**RE: 3122 12<sup>th</sup> Street NW**  
**Grading and Drainage Plan**  
**Engineer's Stamp Date: 10/1/2024**  
**Hydrology File: H13D123**

A PLAN  
FOR A PROPOSED ATTACHED  
30' X 50' GARAGE ADDITION AT  
**3122 12<sup>th</sup> STREET N.W.**  
ALBUQUERQUE, NEW MEXICO  
SEPTEMBER, 2024

**GRADING AND DRAINAGE PLAN**

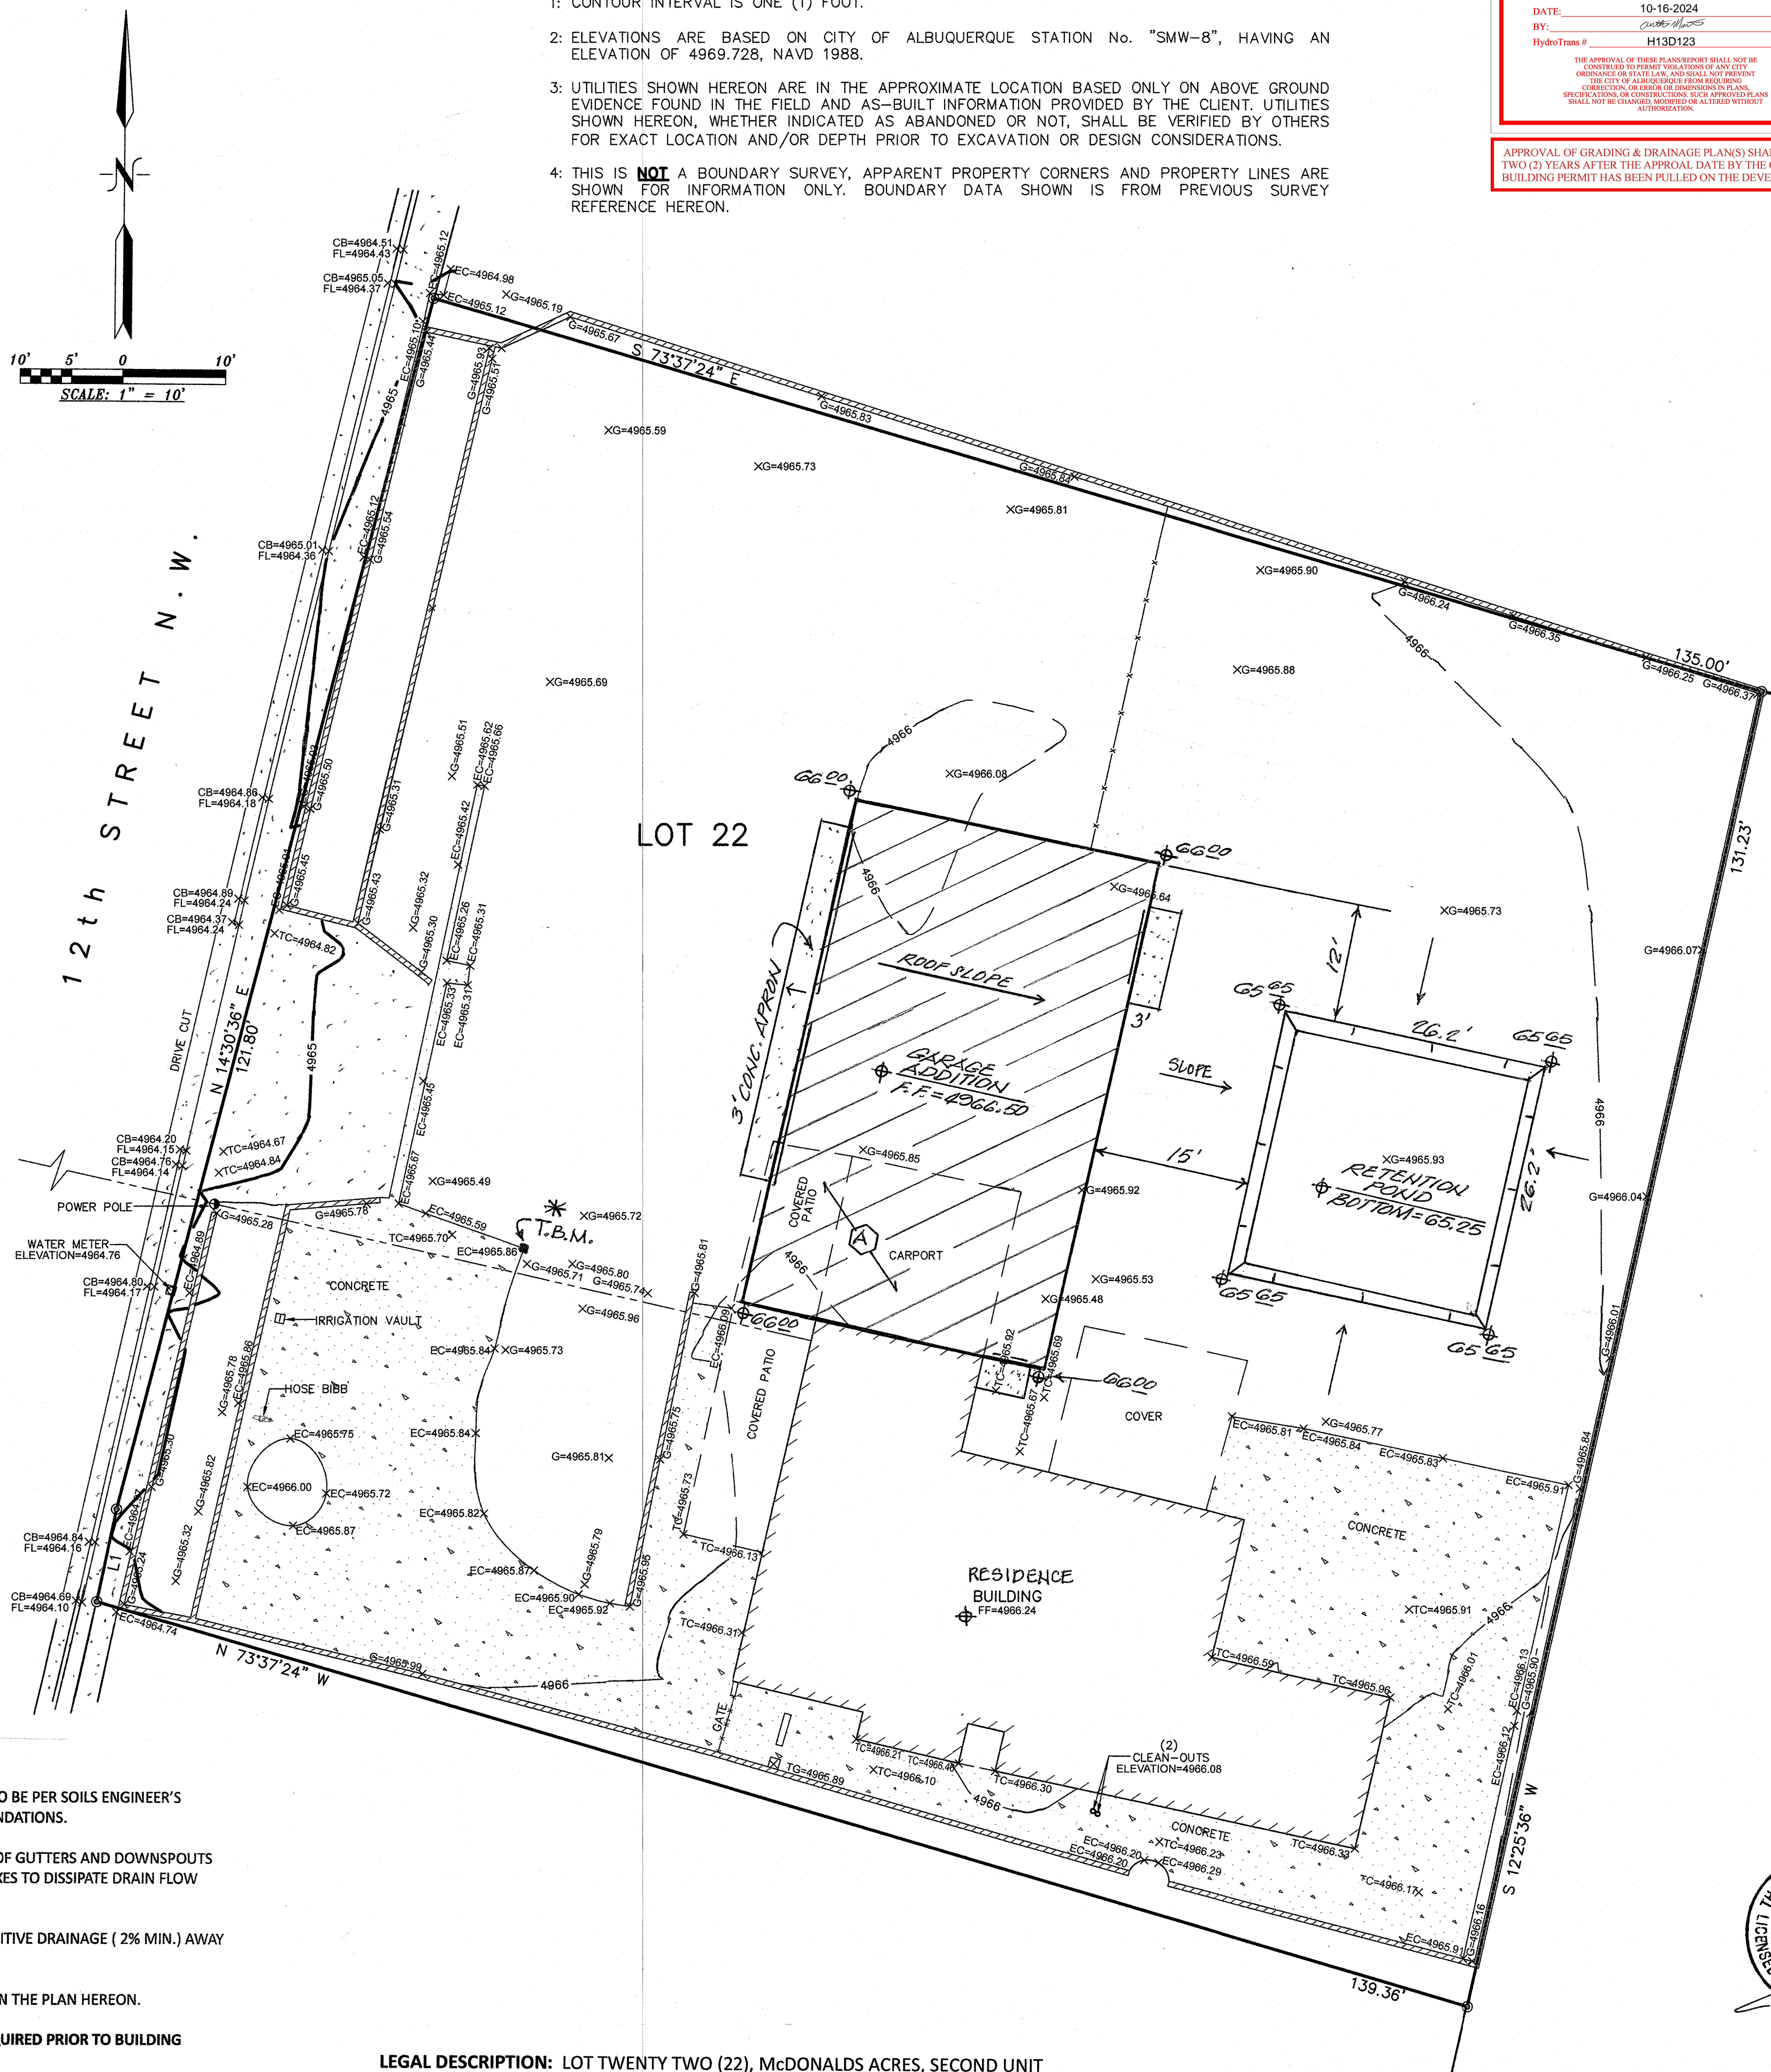
Based upon the information provided in your submittal received 10/08/2024, the Grading & Drainage Plan is approved for Building Permit and Grading Permit. **Since this site is relatively flat and grades to the rear, a pad certification is not needed for this project.** Please attach a copy of this approved plan in the construction sets for Building Permit processing along with a copy of this letter.

1. Engineer's Certification, per the DPM Part 6-14 (F): *Engineer's Certification Checklist For Non-Subdivision* is required.

2. Please provide the executed paper Drainage Covenant (latest revision) printed on one-side only with Exhibit A and a check for **\$25.00** made out to "**Bernalillo County**" for the stormwater quality ponds per Article 6-15(C) of the DPM to Hydrology for review at Plaza de Sol.
